CITY OF TAYLOR, TEXAS

PLANNING AND ZONING COMMISSION MEETING

December 13, 2022, 6:00 P.M.

**MINUTES
CITY OF TAYLOR, TEXAS
400 Porter Street
Taylor, Texas 76574
PLANNING AND ZONING COMMISSION MEETING
November 8, 2022, 6:00 P.M.**

3811 NORTH MAIN PRELIMINARY PLAT
21.782 ACRES SITUATED IN THE
WILLIAM J. BAKER SURVEY, ABSTRACT NO. 65
SAME BEING CONVEYED TO 3811 MAIN STREET LP,
RECORDED IN DOCUMENT NO. 2021158298
OFFICIAL PUBLIC RECORDS, WILLIAMSON COUNTY, TEXAS

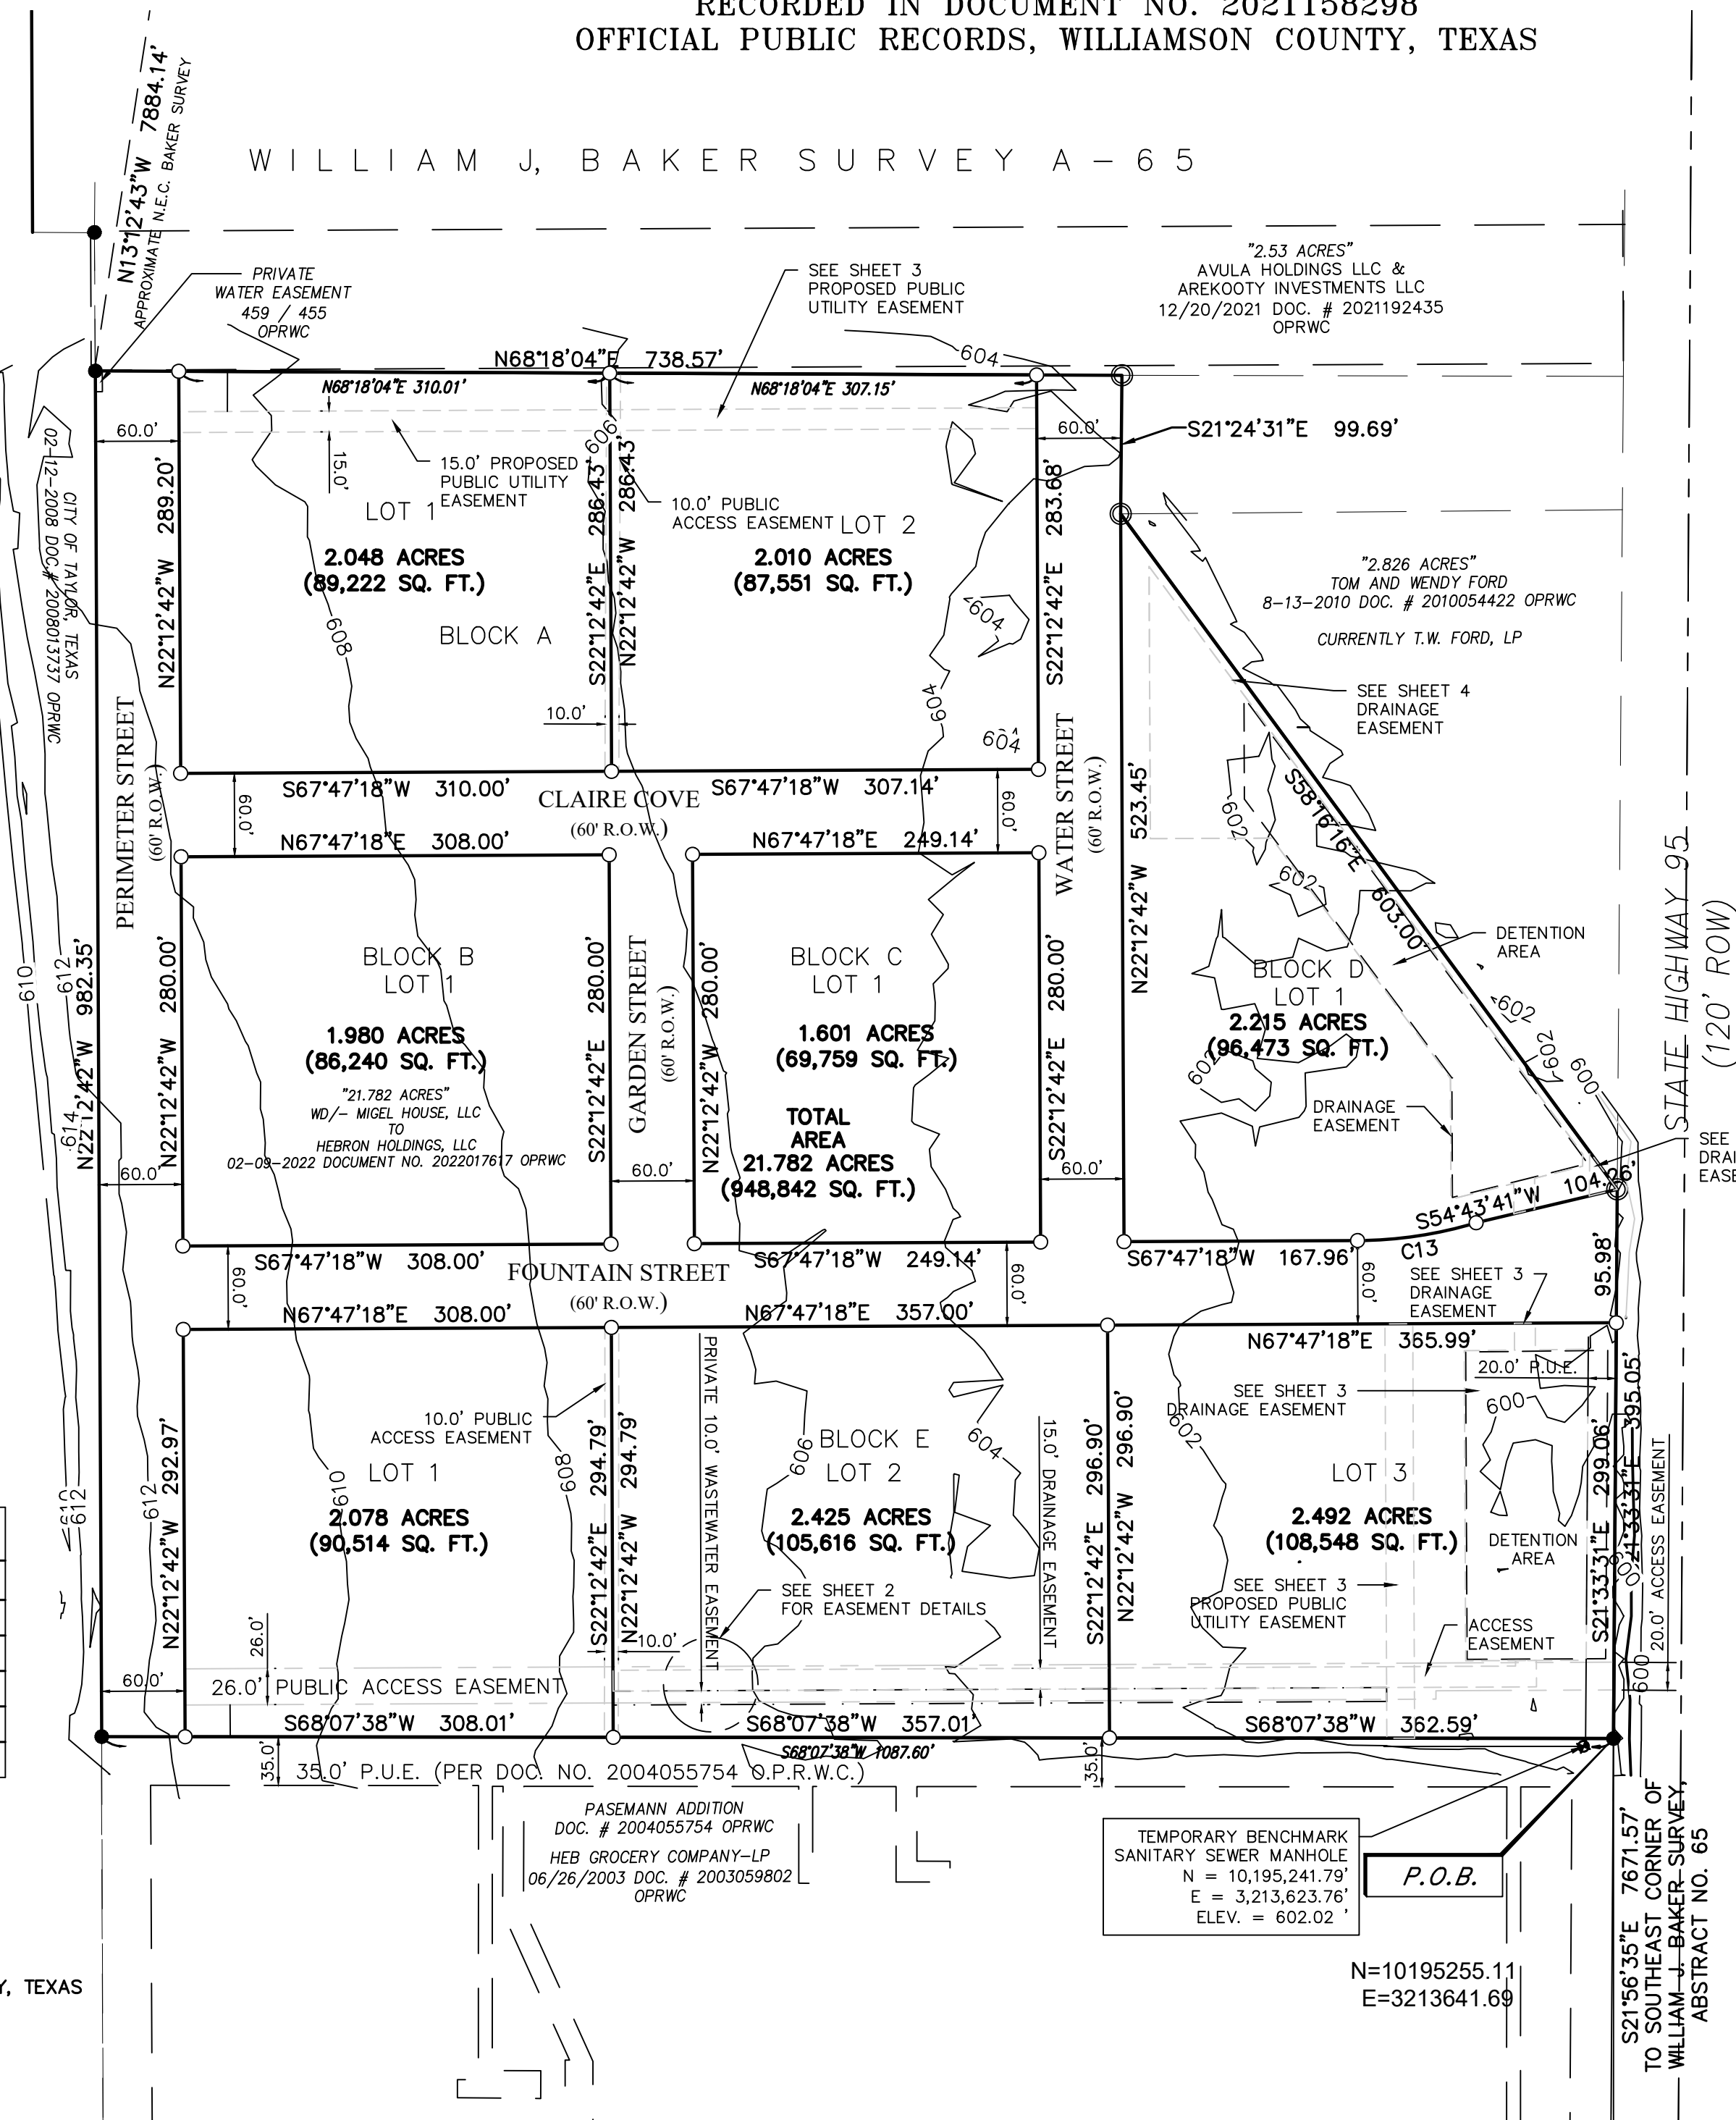
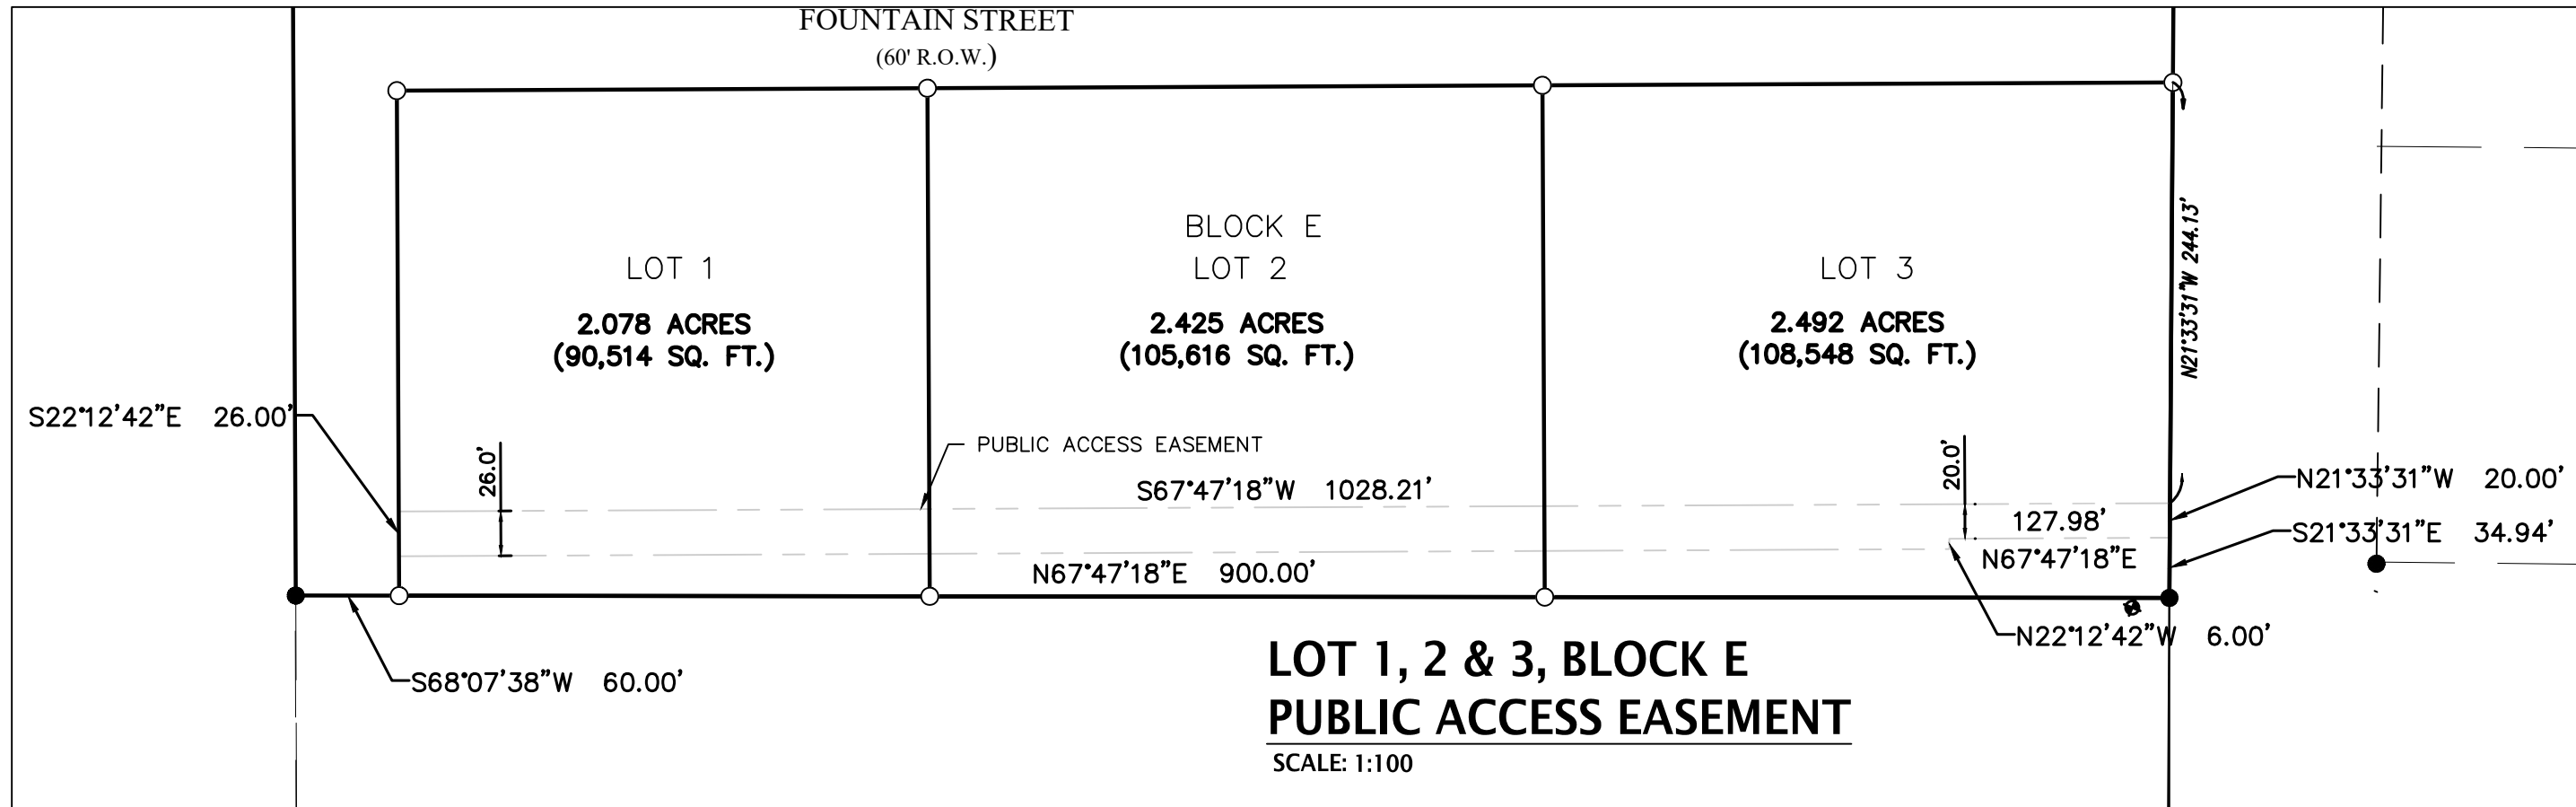
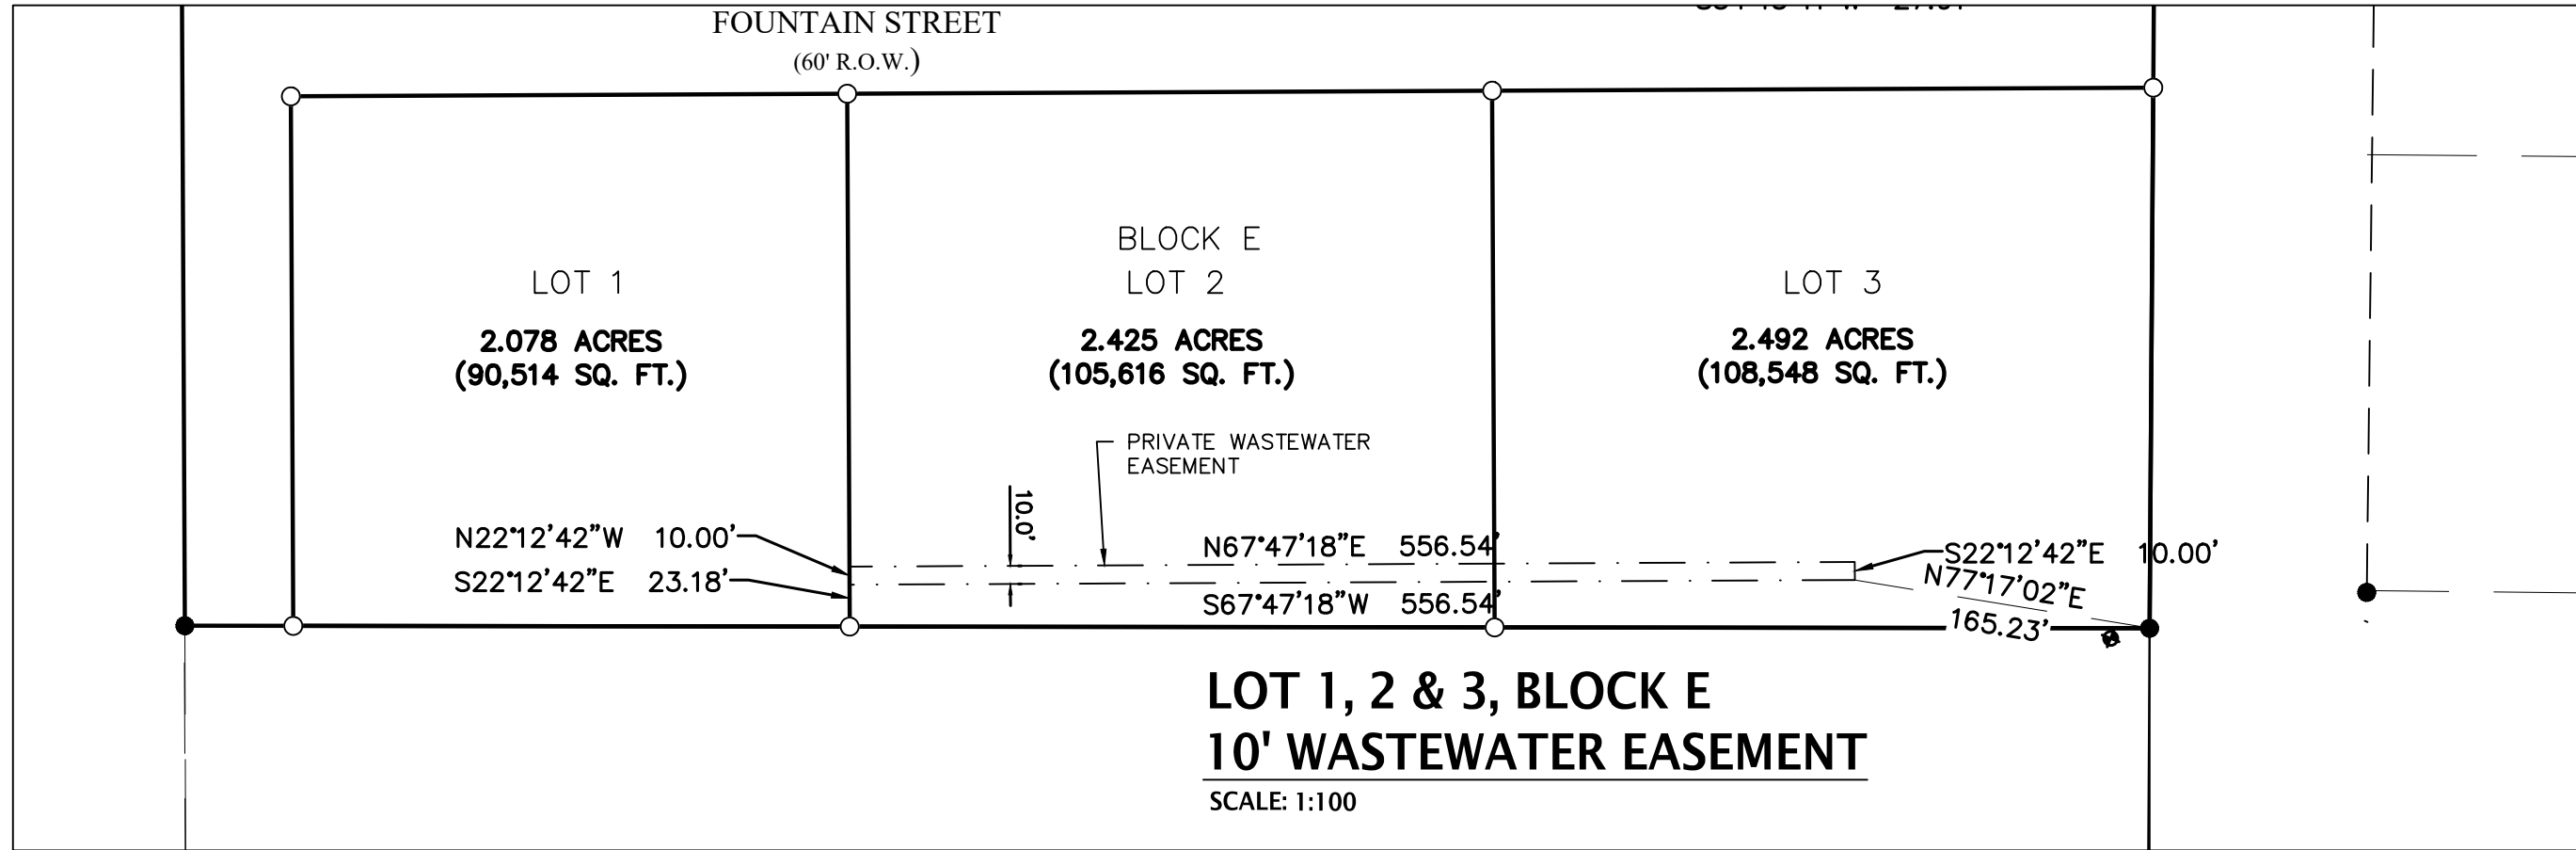
1. All lots must show a 10.0' public utility easement along street frontages. A plat note will not meet this requirement. Moving electrical utilities into the right-of-way has not been historically granted. The applicant should confer with the electric utility provider (ONCOR) to request that their utilities be placed within the right-of-way.

3. A private wastewater line and easement within Block E, Lots 2 and 3 is not standard and not recommended. Wastewater connections should be off the proposed wastewater line along Fountain Street (public right-of-way). Additionally, the schematics for said proposed private water easement etc. should not be part of the preliminary plat. It is understood that this was to provide further detail but pages 2, 3, and 4 should be removed and captured within future steps of development.

1. Update plat to place the proposed detention area outside of the proposed 20-ft P.U.E. along North Main Street.
2. Revise plat to remove proposed "Private Wastewater Easements". Coordination shall be made to coordinate utility schematic for this area.
3. Verify and provide curve table on the plat. The curve table was removed in this submittal.
4. The plat shall reflect how the existing water easement at the northwest corner will be abandoned with this plat.
5. Show 10-ft PUE along all street frontages (TYPICAL).

1. The width of the fire department access road shall be noted.
2. The schematic of the proposed utility plan shall indicate the fire hydrants and the distances between the hydrants that shall be no greater than 500 feet apart.
